CRITICAL AREAS DETERMINATION

NOTICE OF DECISION

Project Number:	CAO17-002
Description:	An application to reduce the buffer from a Type 2 watercourse from 50 feet to 25 feet. The buffer reduction is for the addition to the existing home and mitigation includes removing a gravel parking pad (impervious surface) and planting native vegetation.
Applicant:	Brad Sturman 7939 139 th Avenue SE Newcastle, WA 98059
Owner:	Carl and Donna Platou 8316 Avalon Drive Mercer Island, WA 98040
Site Address:	8613 Avalon Drive, Mercer Island, WA, 98040; Identified by King County Assessor tax parcel number 032110-0290.
Zoning District:	R-8.4
SEPA Compliance:	The proposal underwent SEPA review, processed under file number SEP17-004. A Determination of Nonsignificance was issued on July 31, 2017.
Exhibits:	<ol style="list-style-type: none">1. Site Plan received by the City on July 3, 2017.2. Development Application received by the City on April 4, 2017.3. Project Narrative received by the City on February 20, 2017.4. Geotechnical Engineering Evaluation, prepared by Michael Xue, Senior Geotechnical Engineer at PanGeo, received by the City on February 20, 2017.5. Critical Areas Study, prepared by John Alt

**STREAM BUFFER MITIGATION PLAN
 STREAM BUFFER ENHANCEMENT & PLANTING PLAN
 PLATOU RESIDENCE
 8316 AVALON DR.
 MERCER ISLAND, WA 98040**

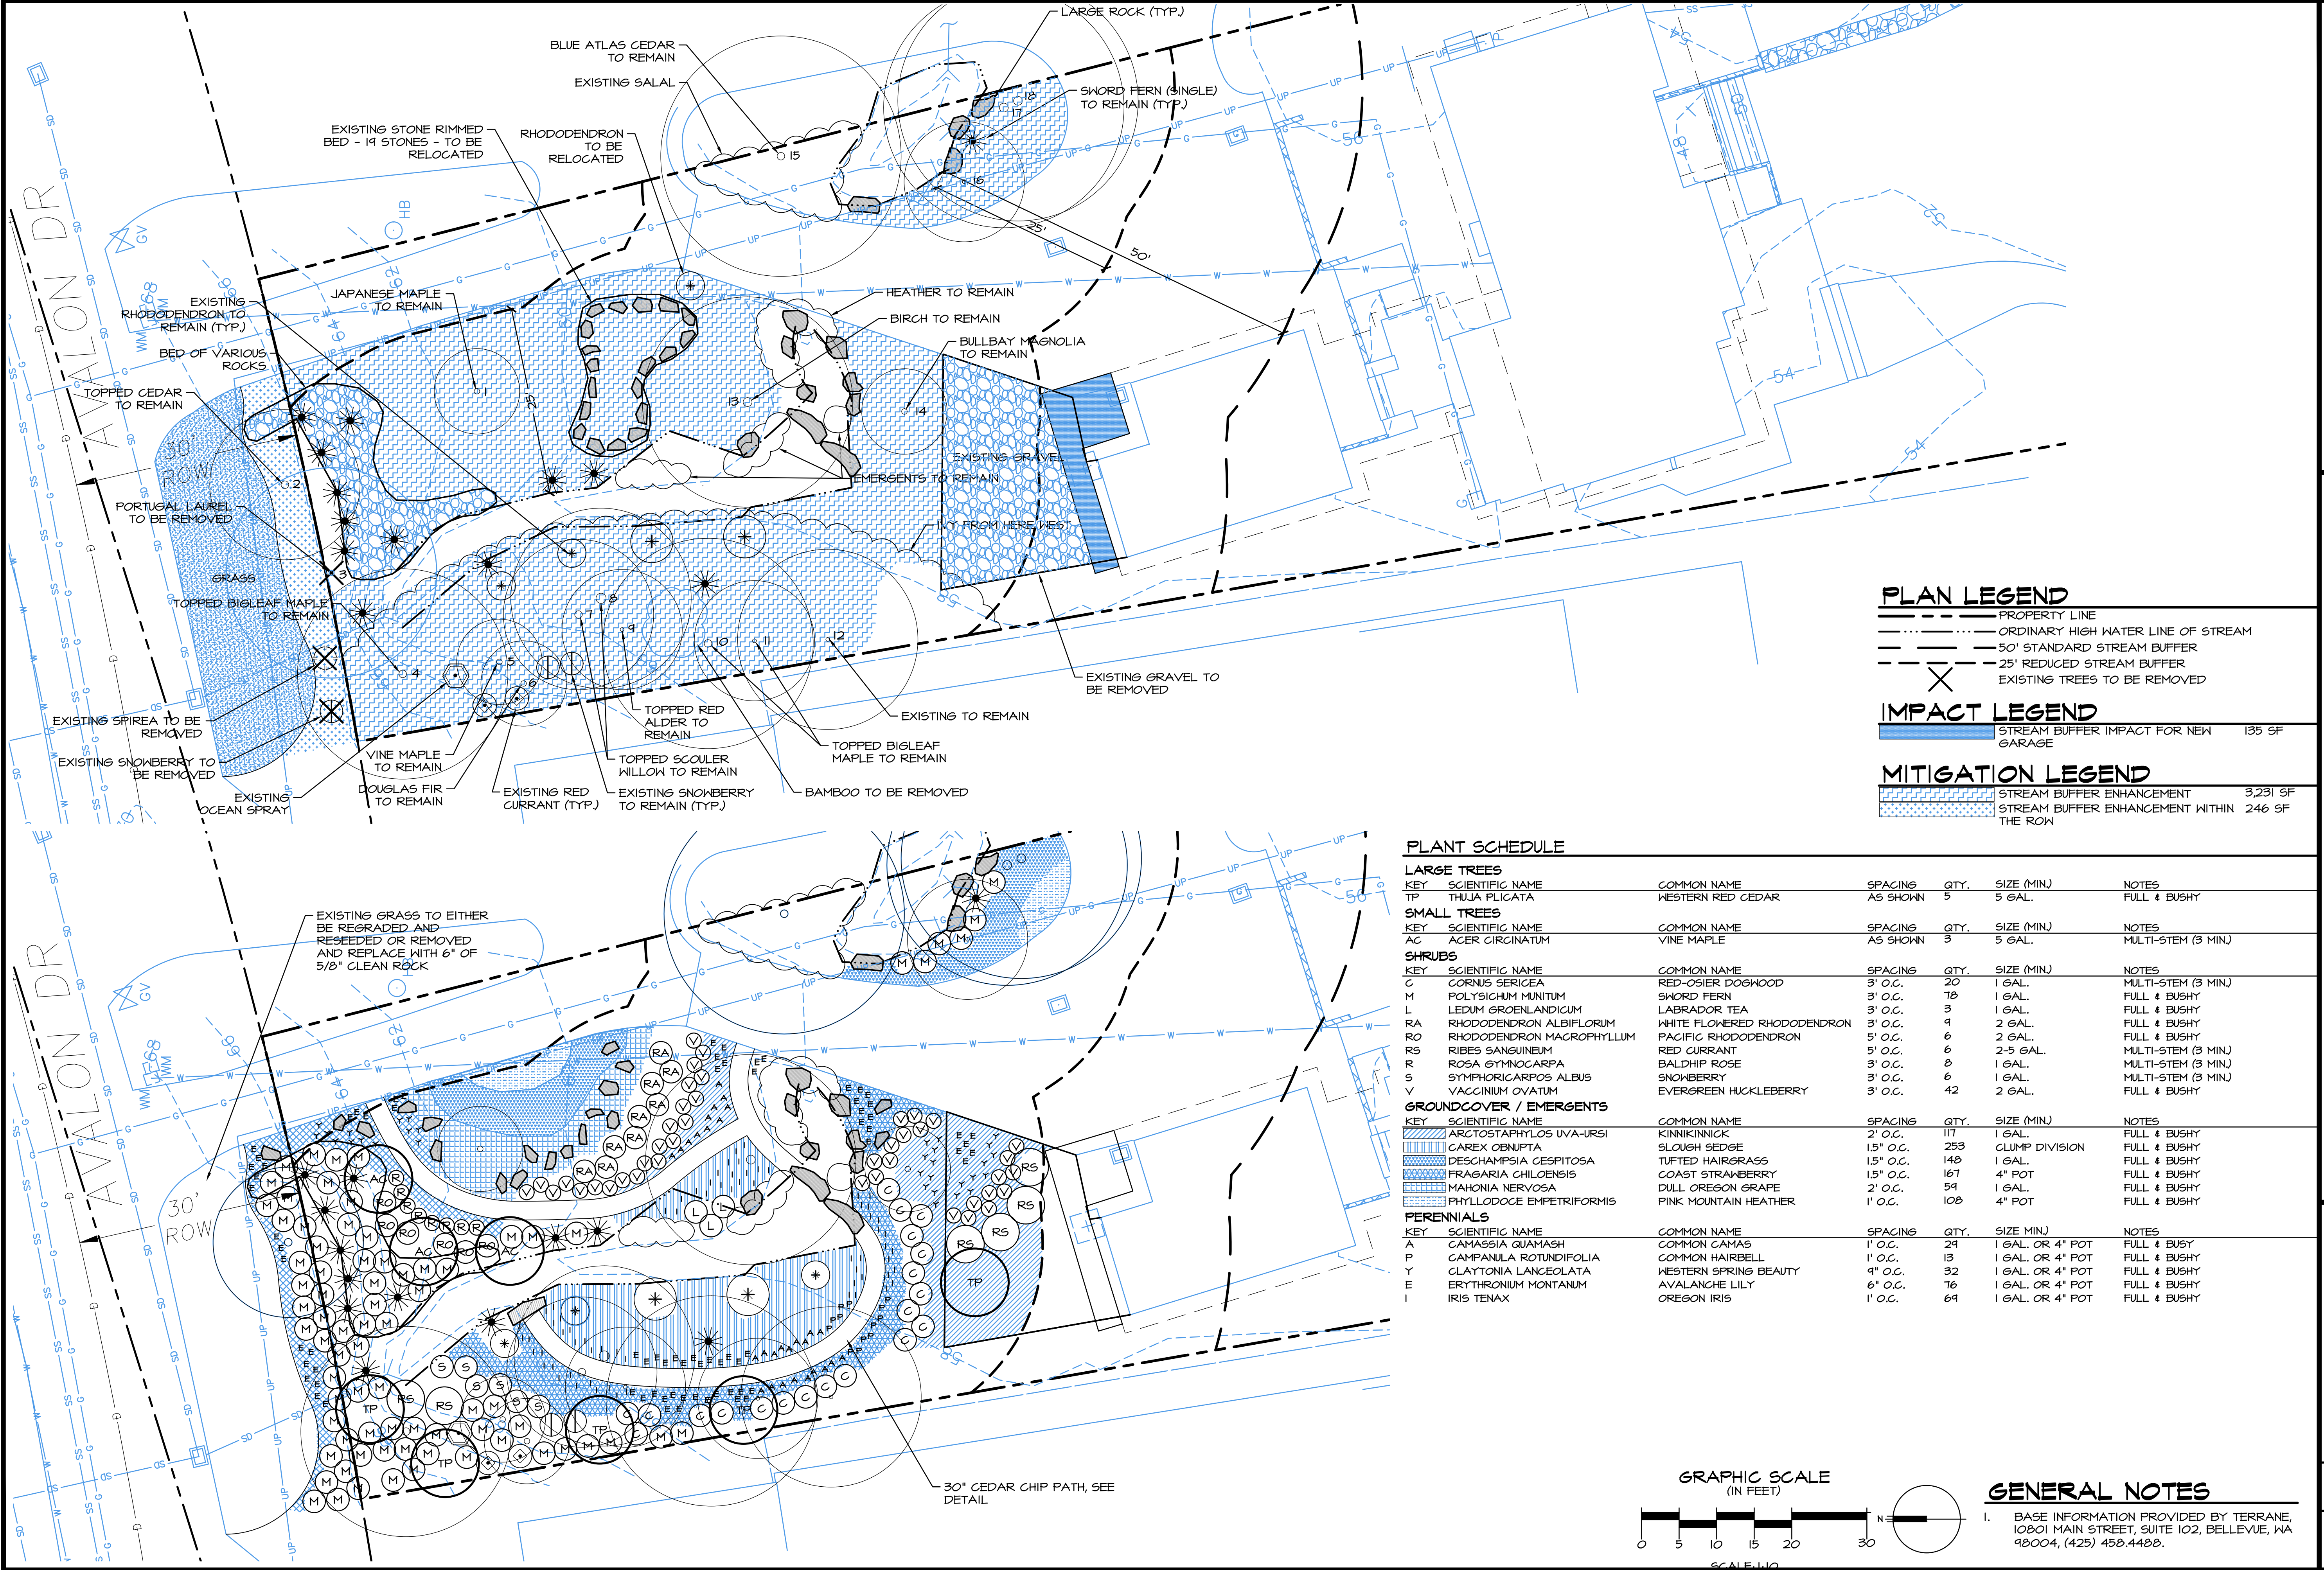
Revisions	Date	By
TO KEEP NATIVE TOPPED TREES	05-11-17	SO
PER CITY COMMENTS	06-23-17	SO

In addition to the expansion project, an existing non-native, invasive Portugal laurel tree will be removed. All the other topped native trees will remain, per City recommendations (see tree legend on **Drawing W-1**).

Figure 1. Markup Showing Approximate Locations of Observed Wet Areas

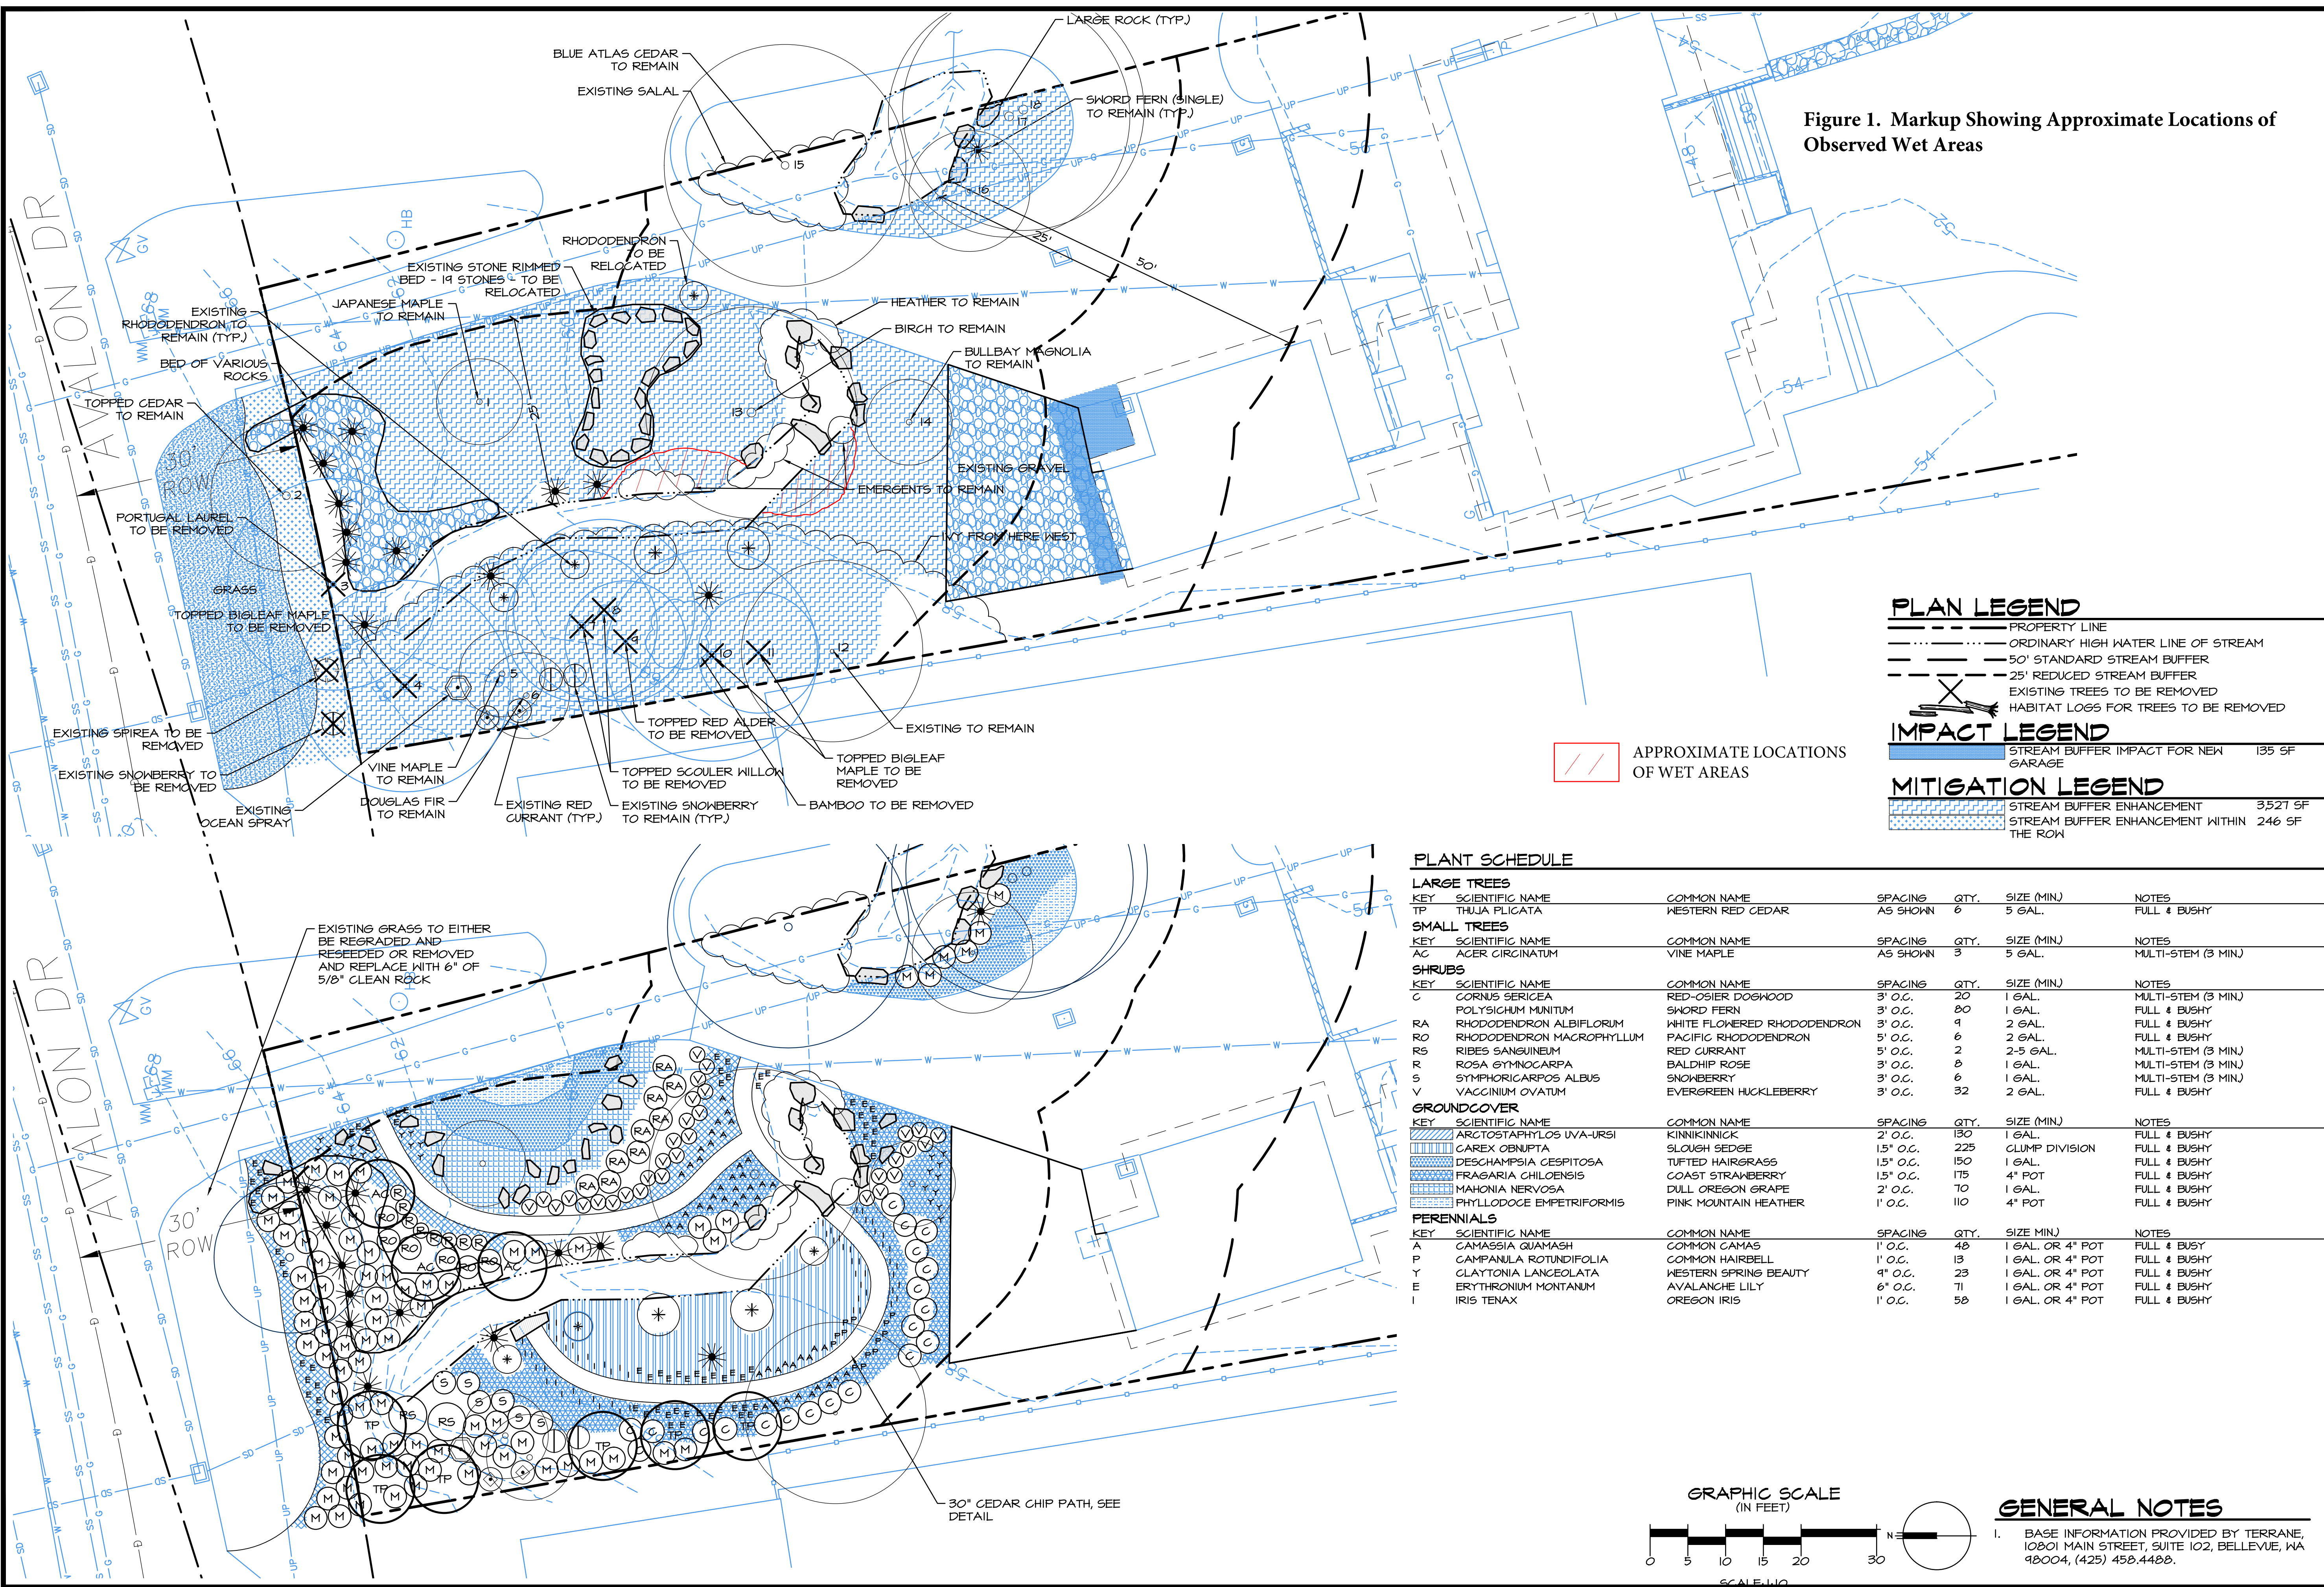
During our site visit, most of the project site consisted of upland plant communities and bright, drier soil that did not suggest wetland conditions. However, in two relatively small areas adjacent to the on-site stream, dark, saturated soils containing redoximorphic features were observed. One of these areas was east of the stream between the stone-rimmed garden area and where the stream turns to the east. The other area was south of this turn, to the north of the gravel parking area. See Figure 1 (marked-up sheet from the Buffer Mitigation Plan) for approximate locations of wet areas. The dominant vegetation in these areas was field horsetail (*Equisetum arvense*). The Critical Areas Study did not identify any wetlands on site and it does not appear that Altmann Oliver Associates established any formal data plots to document existing conditions. Based on our observations, we recommend that the applicant's consultant provide additional information to document existing conditions in these areas. Depending on the findings, it may be appropriate to include these areas within the ordinary high water mark (OHWM) of the stream, or they may be identified as separate wetlands.

- We recommend that an arborist report be developed, as required when removing large trees from a critical tree area.
- We recommend the following updates to the Stream Buffer Mitigation Plan in order to maximize opportunity for mitigation success:

selected for these areas. For the areas noted on Figure 1, we recommend the following plant changes to species more appropriate for wet conditions:

- Substitute sword fern with Labrador tea (*Ledum groenlandicum*)
 - Substitute coast strawberry (*Fragaria chiloensis*) with bunchberry (*Cornus canadensis*)
 - Substitute common camas (*Camassia quamash*) with western columbine (*Aquilegia formosa*)
- The Construction Specifications should specify that pesticides are not permitted within the enhancement area.
